CITY OF ALBUQUERQUE

RE: Starbucks 4201 Central Ave. NW Revised Grading and Drainage Plan Engineer's Stamp Date: 07/12/21 Hydrology File: K12D005

DRAINAGE AND TRANSPORTATION INFORMATION SHEET (REV 11-2018)

DRAINAGE MANAGEMENT PLAN

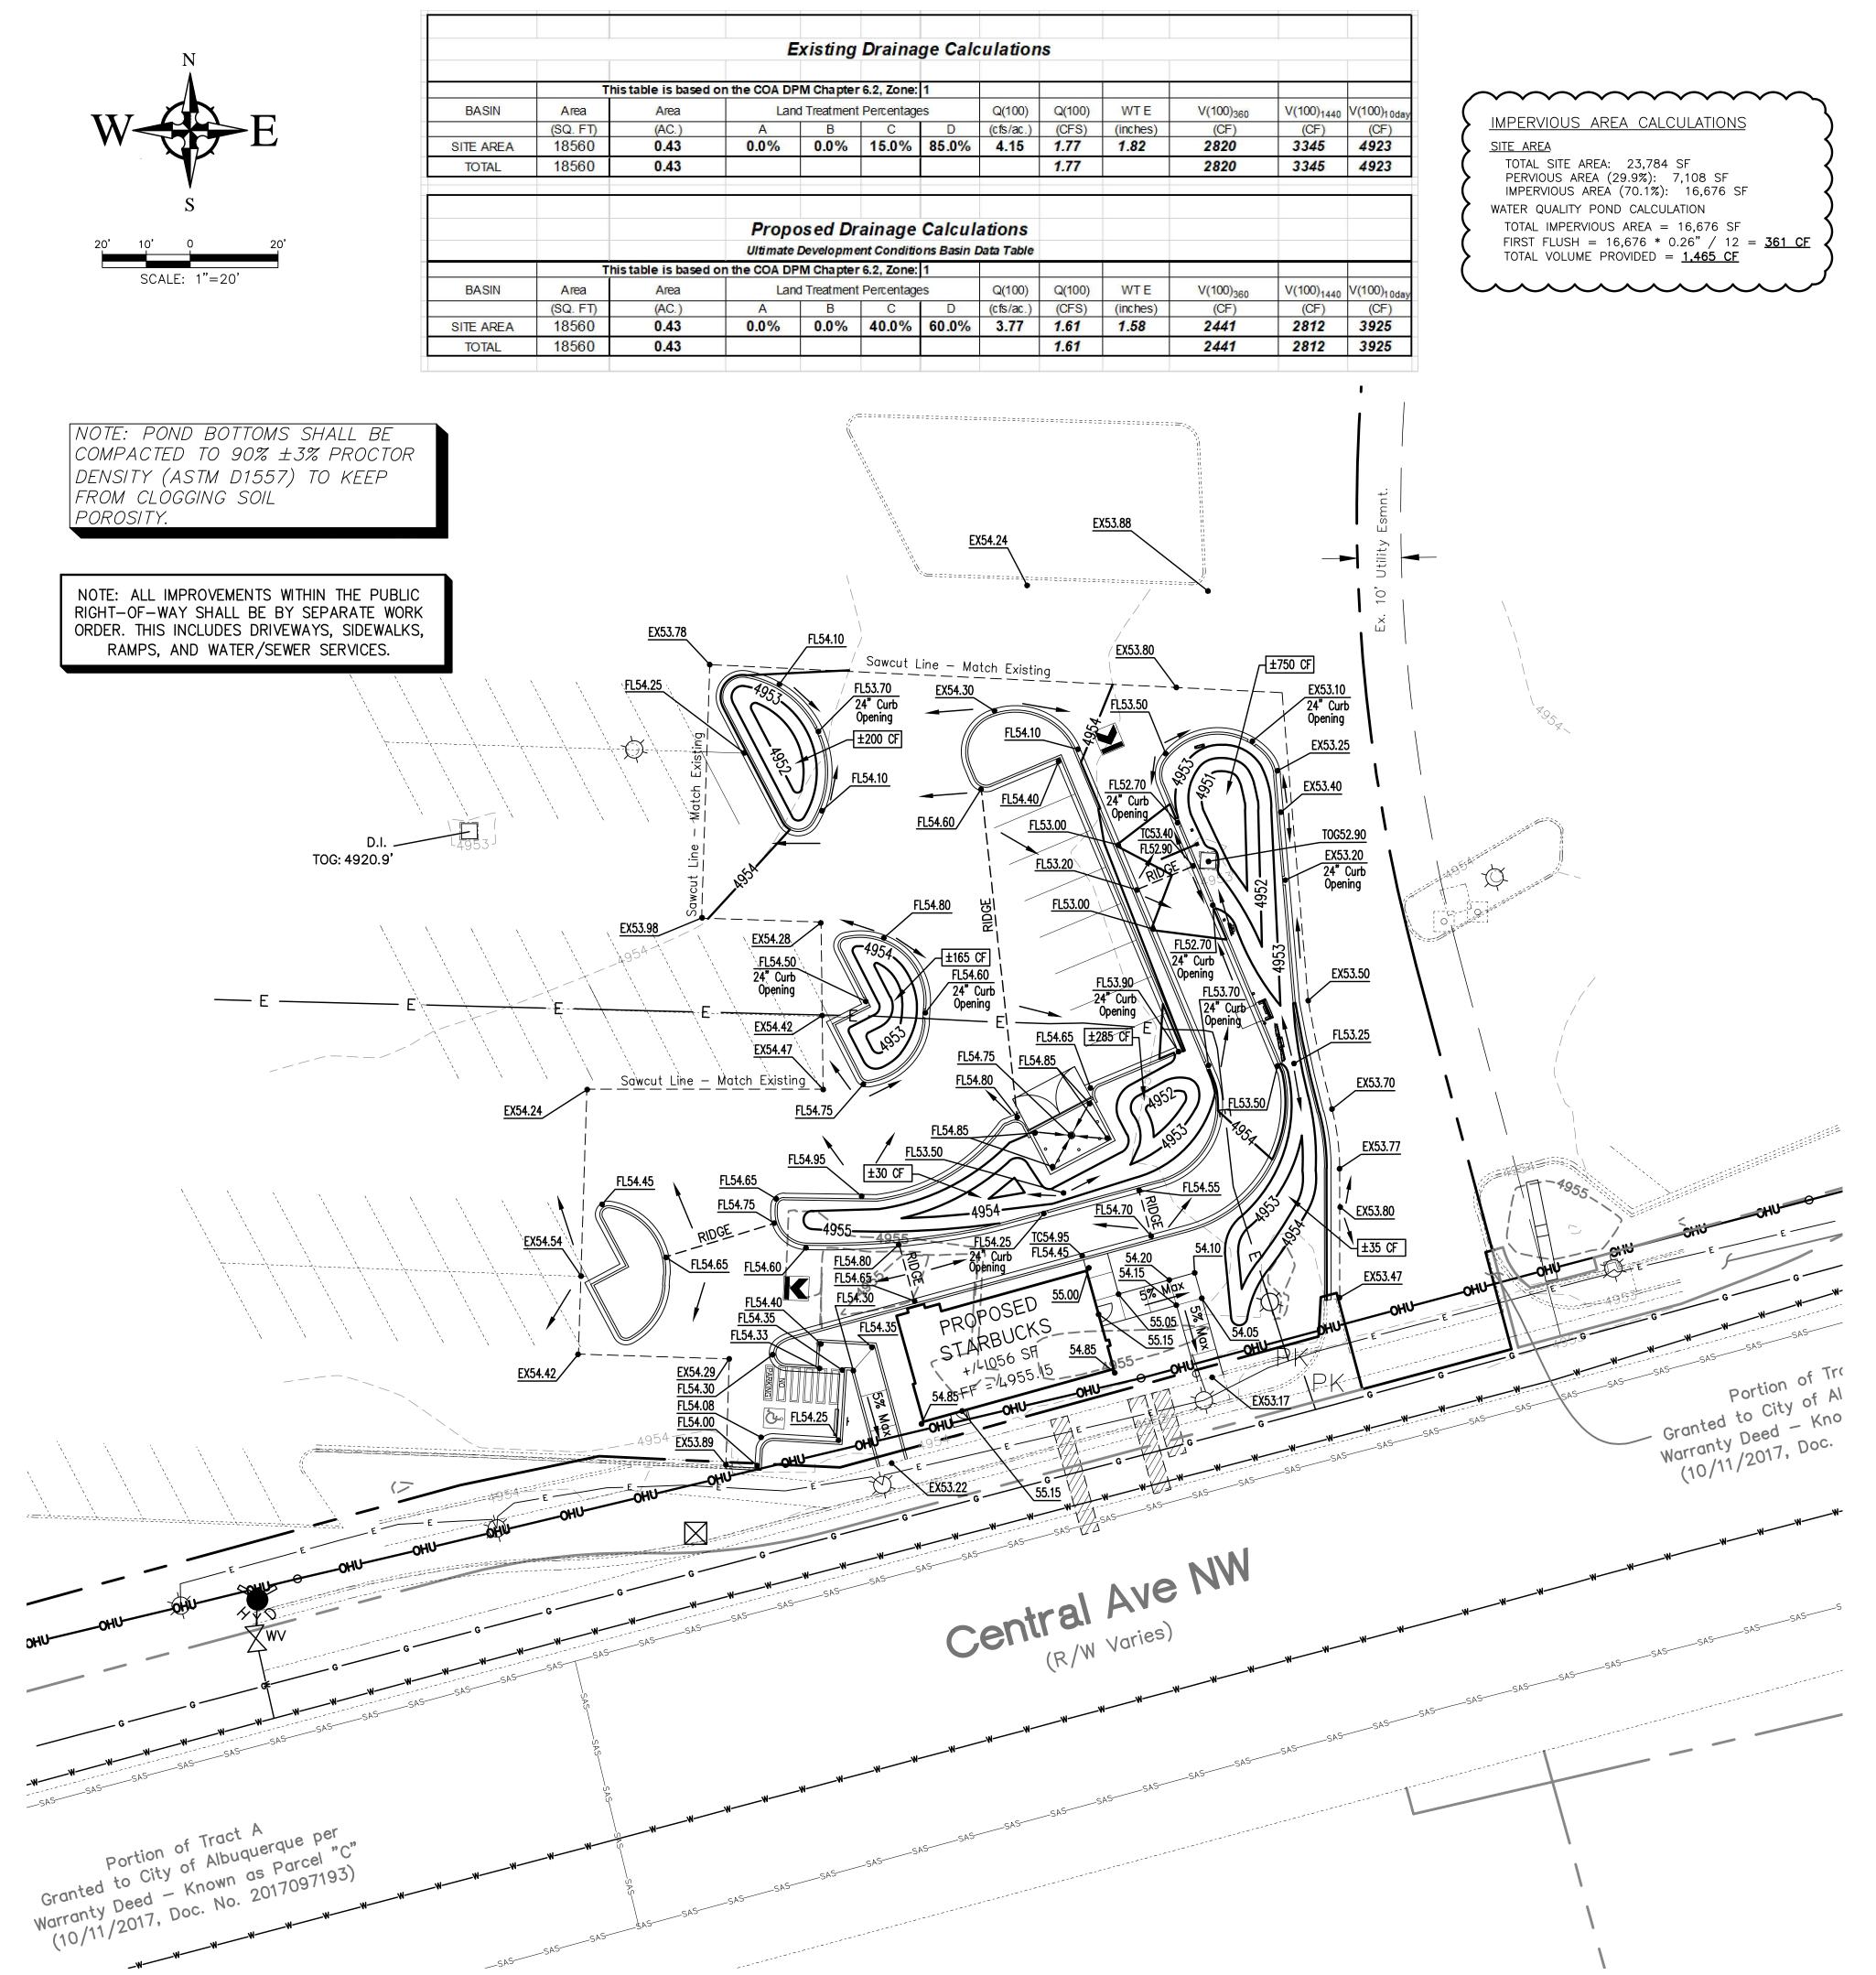
- PO Box 1293 Based upon the information provided in your submittal received 07/08/2021, the Revised Grading and Drainage Plan is approved for Building Permit.
- Albuquerque Please attach a copy of this approved plan in the construction sets for Building Permit processing along with a copy of this letter. Prior to approval in support of Permanent Release of Occupancy by Hydrology, Engineer Certification per the DPM checklist will be required.
- NM 87103 If the project total area of disturbance (including the staging area and any work within the adjacent Right-of-Way) is 1 acre or more, then an Erosion and Sediment Control (ESC) Plan and Owner's certified Notice of Intent (NOI) is required to be submitted to the Stormwater Quality Engineer (Doug Hughes, PE, jhughes@cabq.gov, 924-3420) 14 days prior to any earth disturbance.

Please provide Drainage Covenant for the stormwater quality ponds per Article 6-15(C) of the DPM prior to Permanent Release of Occupancy. Please submit an electronic file of the Covenant and Exhibit for completeness to Marion G. Velasquez at <u>mgvelasquez@cabq.gov</u>.
